UNITED STATES PATENT AND TRADEMARK OFFICE

APPLICATION NO.	FILING DATE	FIRST NAMED INVENTOR	ATTORNEY DOCKET NO.	CONFIRMATION NO.
10/674,354	10/01/2003	Nobuhiro Inoue	243412US3	3815

Office Action Summary	Application No. 10/674,354	Applicant(s) INOUE ET AL.	
	Examiner Jason L. Lazorcik	Art Unit 1731

FIG. 6A

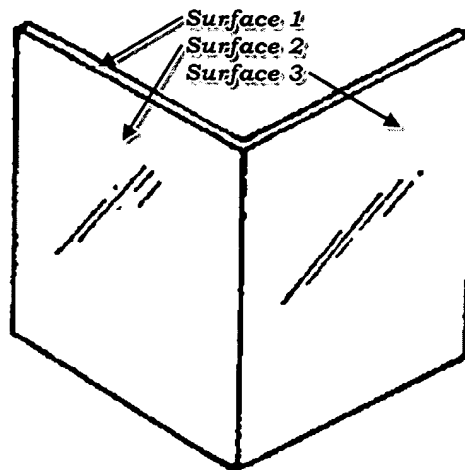
larger than 100mm. Further as clearly depicted in figure 6a, Tomozane teaches a glass sheet which includes a corner where three surfaces connect together and each surface is a flat surface.

Tomozane does not explicitly indicate the applied force needs to comply with the relationship as set forth in formula 2. It is understood from the applicants specification that controlling the "bending evaluation index" value to the range outlined in claim 1 is performed in order to avoid the formation of a wrinkle in a peripheral edge of the sheet or "the formation of several kinds of optical distortions in the glass sheet" (Specification pg 3, Lines 10-14). Tomozane clearly indicates that the applied force or applied pressure as a function of time is "***precisely controlled***" to preclude the generation of cracks or a kind of "optical distortion" at the bend area. In addition, the Tomozane process is undertaken on glass material heated to a viscosity falling within the claimed range of 10^5 to 10^8 poise. It would have therefore been obvious to one of ordinary skill
